PLANNING APPLICATION RESPONSE LETTER

PROJECT ADDRESS: 1609 and 1615 Grand Avenue
PLN RECORD #: PLN2024-00181
DATE: Friday, September 27, 2024 – Review # 2
APPLICANT: Ben Eilenberg, GRAND SANTA BARBARA LLC
socialindustrialequities@gmail.com
ASSIGNED PLANNER: Barbara Burkhart, BBurkhart@SantaBarbaraCA.gov
STATUS: INCOMPLETE

d. Maneuvering Depth.

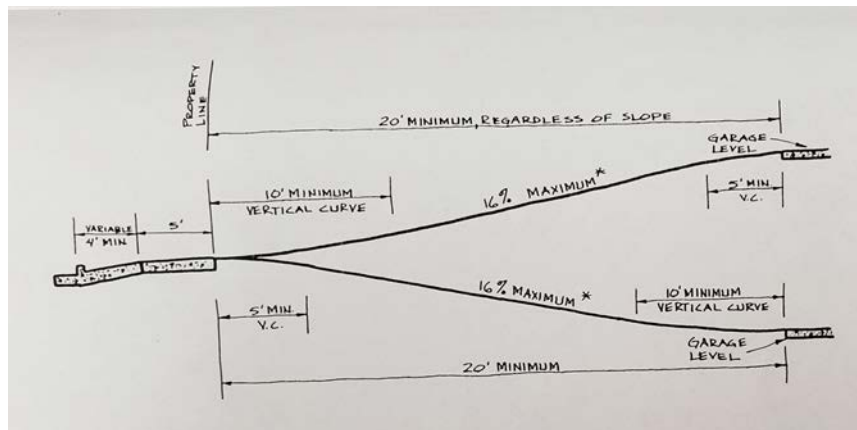
i. Parking Garage (P1):

- 1. Dimension the required minimum maneuvering depth for all the proposed parking stalls.
- 2. The three proposed compact parking stalls appear to conflict with the proposed trash enclosure. Revise the plans to propose a rolling gate and a minimum 23'-0" of maneuvering depth (not 22'-0").
